Re: Florida Power & Light Company
Proposed Turkey Point Units 6 and 7
Docket Nos. 52-040 and 52-041
Response to NRC Request for Additional Information Letter No. 58 (eRAI 6434) -
Concerning Implementation of Fukushima Near-Term Task Force Recommendations

Attachment: FPL Response to NRC RAI No. 01.05-1 (eRAI 6434)

NRC RAI Number: 01.05-1 (eRAI 6434)

Figure 1: Seismotectonic Source Zones

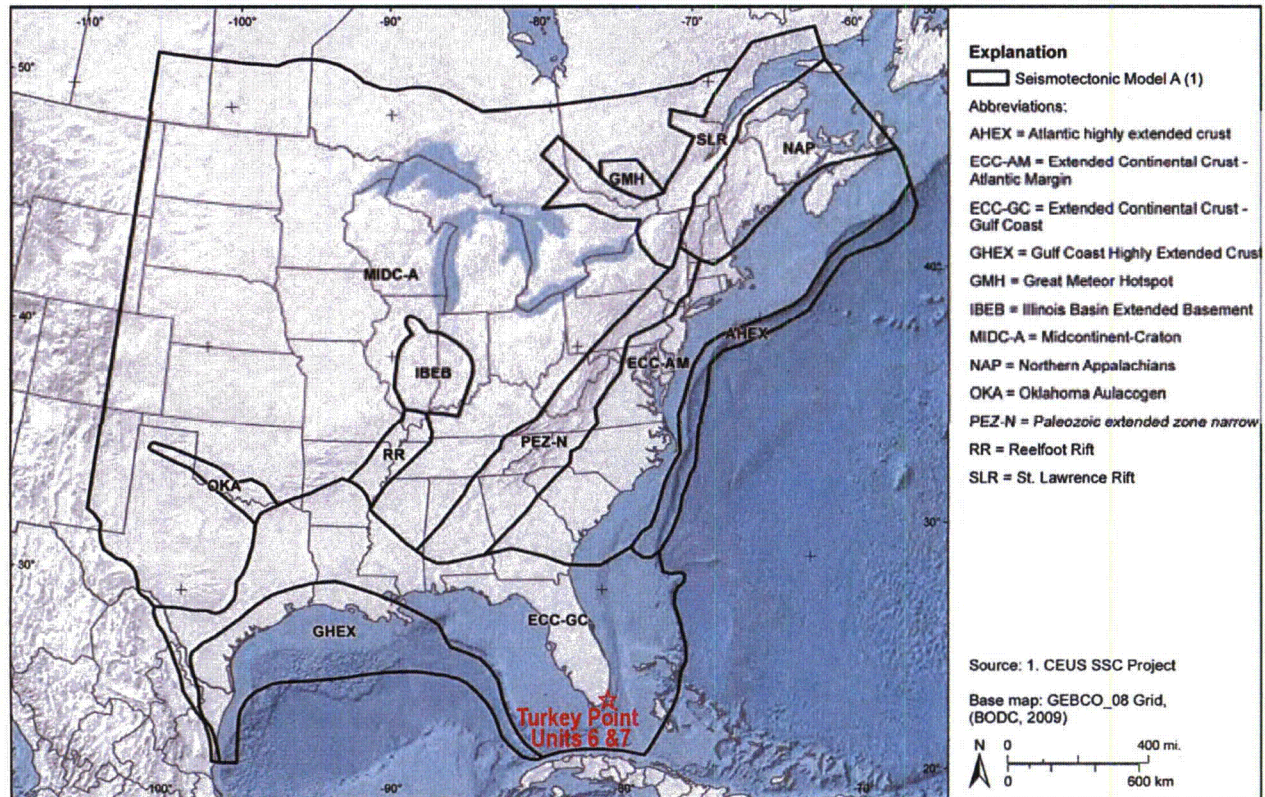
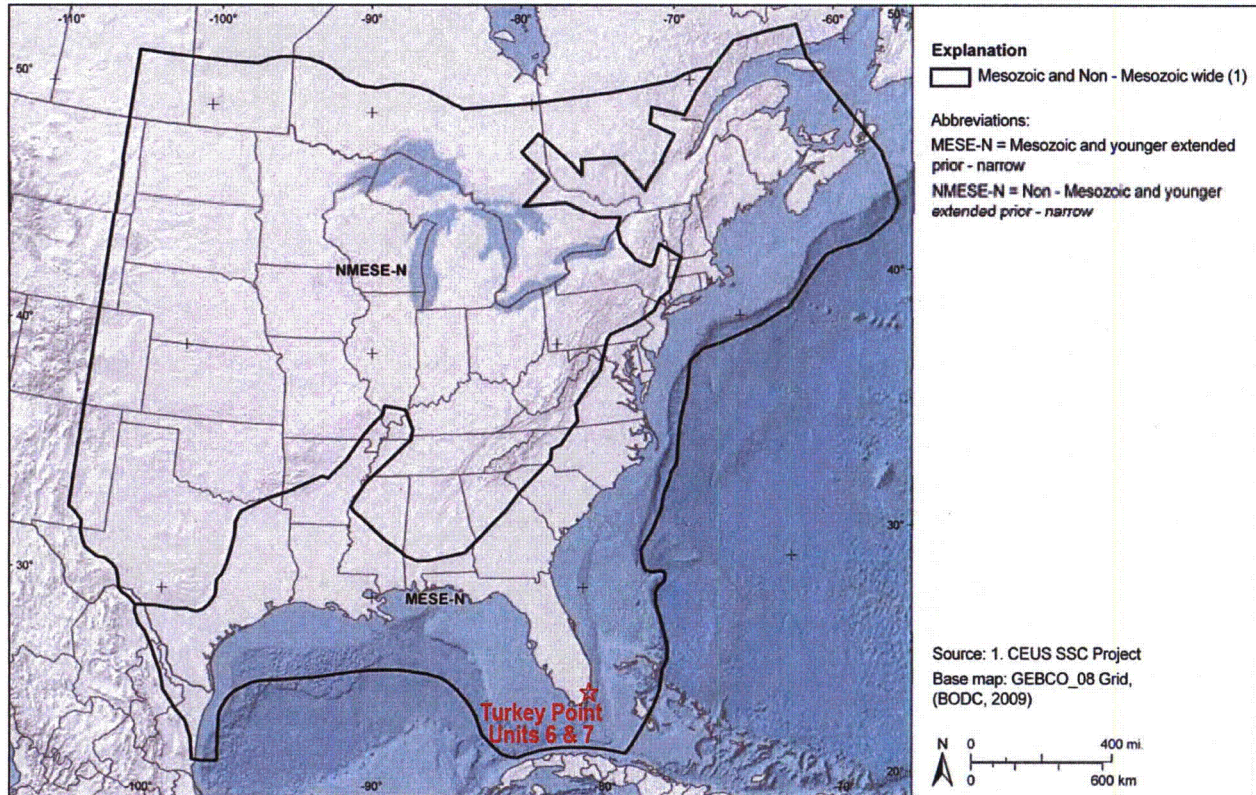
- a) Evaluate the potential impacts of the newly released CEUS SSC model, with potential local and regional refinements as identified in the CEUS SSC model, on the seismic hazard curves and the site-specific ground motion response spectra (GMRS)/foundation input response spectra (FIRS). For re-calculation of the PSHA, please follow either the cumulative absolute velocity (CAV) filter or minimum magnitude specifications outlined in Attachment 1 to Seismic Enclosure 1 of the March 12, 2012 letter "Request for information pursuant to Title 10 of the *Code of Federal Regulations* 50.54(f) regarding Recommendations 2.1, 2.3, and 9.3, of the near-term task force review of insights from the Fukushima Dai-Ichi accident." (ML12053A340).
- b) Modify the site-specific GMRS and FIRS if you determine changes are necessary given the evaluation performed in part a) above.

Figures 1 and 2 show examples of the source zones of the CEUS Seismic Source Characterization (SSC) model developed in NUREG-2115 (Reference 1). Figure 1 shows example seismotectonic source zones and Figure 2 shows example Mmax source zones. The areal extent of the CEUS SSC model covers the region encompassed by the updated EPRI-SOG seismic sources shown on FSAR Figures 2.5.2-204 through 2.5.2-209. Thus, the CEUS SSC model can be considered as a replacement for the EPRI-SOG (FSAR Reference 2.5.2-245) seismic sources in their entirety. As a consequence, an assessment of the effect of the CEUS SSC model on the total hazard curves for the site can be evaluated by subtracting from the existing total hazard the contribution of the updated EPRI-SOG sources and then adding the hazard contributed by the CEUS SSC model sources to produce total hazard values for the purpose of the sensitivity analysis.
